Access Compliance Report

Public Rights-of-Way

(Pedestrian Signals)

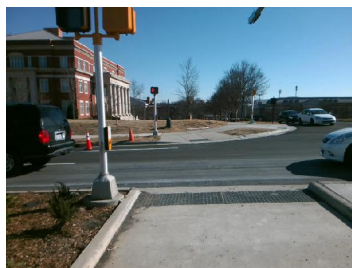
PROW/ADA: R404.2, R404.3, R404.7.2

N/A	B 1 FWD Approach Width (in)	N/A	N/A	B 2 FWD Approach Width (in)	N/A
N/A	B 1 FWD Approach Obstruction?	Yes	N/A	B 2 FWD Approach Obstruction?	N/A
N/A	B 1 FWD Approach Obstruction Dist (in)	4.0	N/A	B 2 FWD Approach ObstructionDist (in)	N/A
N/A	B 1 PARA Approach?	Yes	N/A	B 2 PARA Approach?	N/A
N/A	B 1 PARA Approach Constrained?	Yes	N/A	B 2 PARA Approach Constrained?	N/A
Yes	B 1 PARA Approach Reach (in)	10.0	N/A	B 2 PARA Approach Reach (in)	N/A
No	B 1 PARA Approach Width (in)	48.0	N/A	B 2 PARA Approach Width (in)	N/A
N/A	B 1 PARA Approach Obstruction?	Yes	N/A	B 2 PARA Approach Obstruction?	N/A
N/A	B 1 PARA Approach Obstruction Dist (in)	5.0	N/A	B 2 PARA Approach ObstructionDist (in)	N/A
No	B 1 Clear Floor Space Slope (%)	3.6	N/A	B 2 Clear Floor Space Slope (%)	N/A
Yes	B 1 Clear Floor Space XSlope (%)	0.0	N/A	B 2 Clear Floor Space XSlope (%)	N/A
N/A	B 1 PAR Slope (%)	N/A	N/A	B 2 PAR Slope (%)	N/A
Yes	B 1 Height (in)	39.0	N/A	B 2 Height (in)	N/A

Possible Solutions: Remove and Replace Clear Space.
